SLANE BYPASS & PUBLIC REALM ENHANCEMENT SCHEME

Additional Information Response Document

ABP-318573-23

comhairle chontae na mí
meath county council

Figure 4.1: Typical Illustration of a Geogrid Scour Prevention Mat

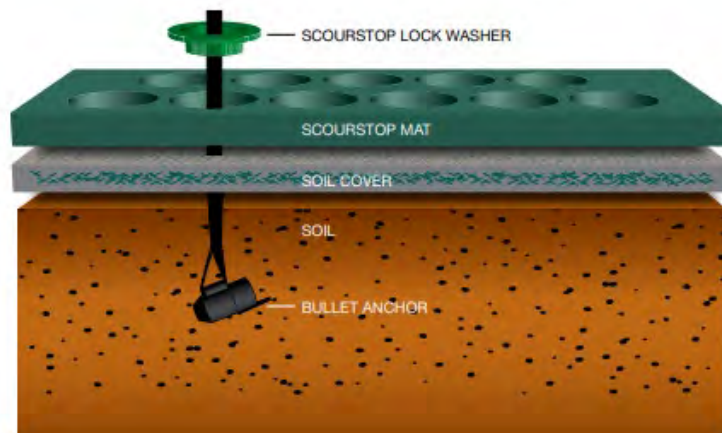
b) *"An exception is noted to the 10m exclusion zone from the riverbank (e.g. Natura Impact Statement Section 6.2.1.1.1.) for the construction of four outfalls. The applicant shall clarify if this relates to the scour mats shown in drawing DR0004. As there is no further reference to these works in the Natura Impact Statement or Environmental Impact Assessment Report Biodiversity chapters, provide an assessment of same, and describe any mitigation measures (e.g. manual installation, timing of works) required to avoid adverse effects to qualifying interest of the European Sites, or any other habitats, flora or fauna."*

The applicant confirms that the exception related to the 10 m exclusion zone from the riverbank is for the construction of the scour mats at two proposed outfalls to the River Boyne as illustrated on Vol. 3 – Scheme Drawings, drawing MDT0806-RPS-01-N2-DR-C-DR1004.

The proposed methodology includes for a geogrid scour prevention mat to be laid over the existing ground and anchored to depth within the underlying soils. See the typical illustration in **Figure 4.1** below.

To construct the scour protection within the 10 m riverbank exclusion zone, the scour mats are laid down on the existing ground surface by manual methods. To firmly secure the scour mats in place, anchors are manually hammered into the ground. This process firmly embeds the scour mat into the topsoil, anchored to the sub-soil and as the mats are a mesh construction, vegetation will continue to grow through the mat over time, restoring a completely natural appearance.
